UNITED STATES
NUCLEAR REGULATORY COMMISSION
WASHINGTON, D.C. 20555-0001

SUBJECT: ISSUANCE OF AMENDMENTS (TAC NOS. M83108, M83109, AND M83110)
(TS 301)

The Commission has issued the enclosed Amendment Nos. 199, 216, and 172 to Facility Operating License Nos. DPR-33, DPR-52 and DPR-68 for the Browns Ferry Nuclear Plant, Units 1, 2, and 3, respectively. These amendments are in response to your application dated March 25, 1992, and supplements dated January 29, 1993 and August 27, 1993.

Figure 4.8-1b
LAND SITE BOUNDARY

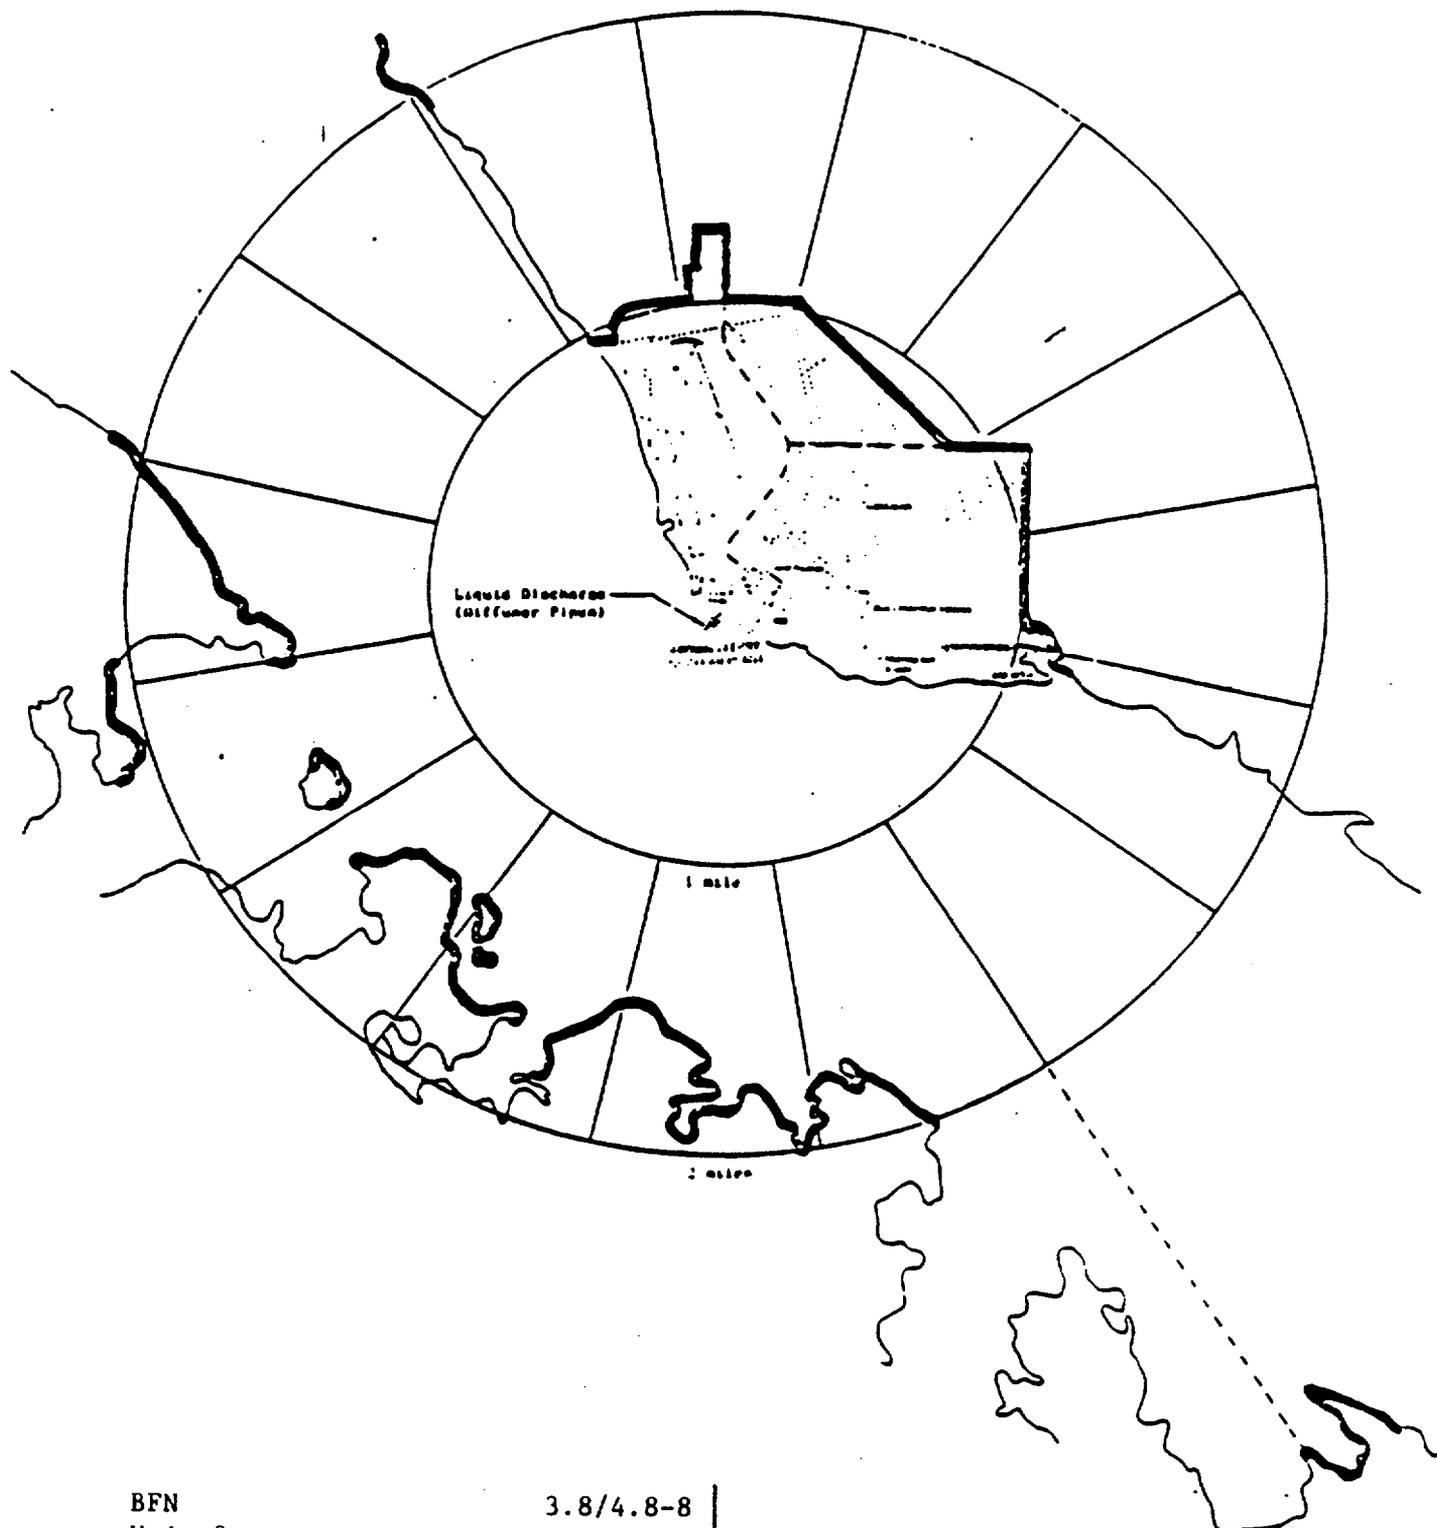
<u>SPECIFICATION</u>	<u>TITLE</u>
1.0.BB	ODCM
1.0.DD	PROCESS CONTROL PROGRAM
Figs. 4.8-1 a&b	GASEOUS RELEASE POINTS & LAND SITE BOUNDARY
3/4.2.K	EXPLOSIVE GAS MONITORING INSTRUMENTATION (Retained existing requirements of this specification with revised bases) (Refer to section 2.2 below for further detail)
3.8.A.5,6 4.8.A.6	LIQUID HOLDUP TANKS (WITH BASES ADDED)
3.8.B.9,10 4.8.B.5	EXPLOSIVE GAS MIXTURES (WITH BASES ADDED)
3/4.8.D	MECHANICAL VACUUM PUMP
3/4.8.E	MISCELLANEOUS RADIOACTIVE MATERIAL SOURCES
